Mine Ventilation Plan, Section 75.370, 30 CFR 75, Upper Big Branch Mine-South, I.D. No. 46-08436, Performance Coal Company, Montcoal, Raleigh County, West Virginia

Performance Coal Company Upper Big Branch Mine MSHA ID: 46-08436 State ID: U-3042-92

Ventilation Revision

# TYPICAL LONGWALL FACE VENTILATION Performance Coal Company Upper Big Branch Mine 46-08436 (U-3042-92) No. 1 North Panel Start-Up

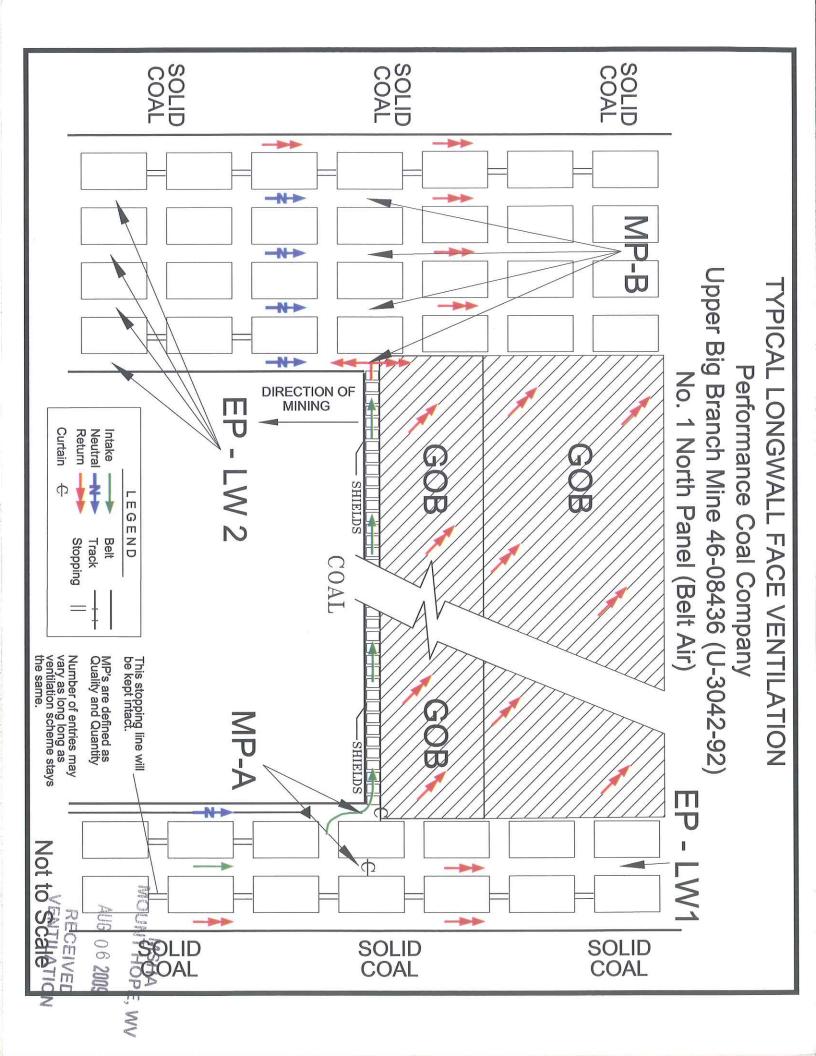
Bleeder evaluation checkpoints, Evaluation Points (EP's), and Monitoring Points (MP's), will be established and maintained within the bleeder system district as each longwall panel is completed. EP's and MP's will be established in the headgate and tailgate entries of the retreating longwall face, to assure proper air flow quality and quantity. These checkpoints will be located inby on the headgate side and outby on the tailgate. During mining the EP's LW - 1 and LW - 2 and MP's A and B will move outby as the longwall face advances (See Typical Longwall Face Sketch).

Doors will be maintained from the active tailgate entry into the adjacent longwall bleeder entries in order to determine air quality in the adjacent longwall gob. In order to facilitate safe inspection, supplemental support will be installed on 4ft centers from the door to the bleeder entry. These MP's will be maintained no more than 3,000ft apart. Measurements will be taken at these locations until the active longwall retreats outby these points.
